WABO PERMIT (ADDENDUM, NOT FOR CONSTRUCTION)
WABO VERGUNNING (ADDENDUM, NIET VOOR BOUW)
21-04-23

Project Number/Projectnummer: P.020212

KANTOORGEBOUW BEGANE GROND -
OFFICE BUILDING GROUND FLOOR PLAN

Sheet Number/Nummer blad:
HUB01-A-2400-0-PRM

1 KANTOORGEBOUW BEGANE GROND - OFFICE BUILDING GROUND FLOOR
1 : 100

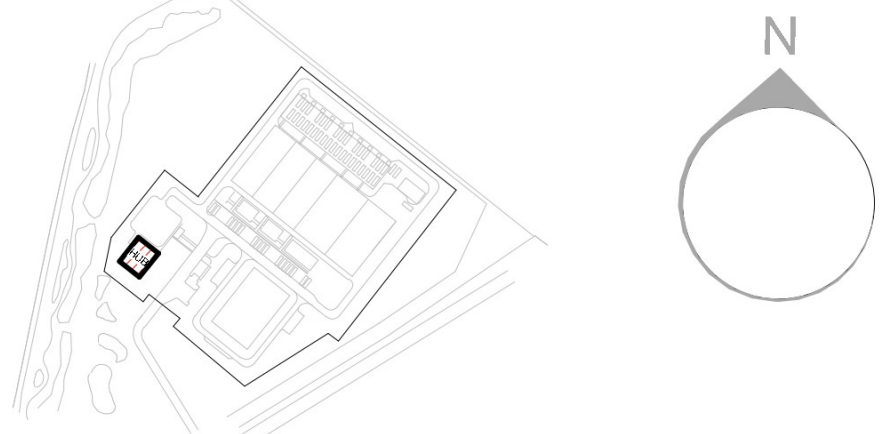
NOTE:
Red clouds show the changes in relation to the previous WABO submission
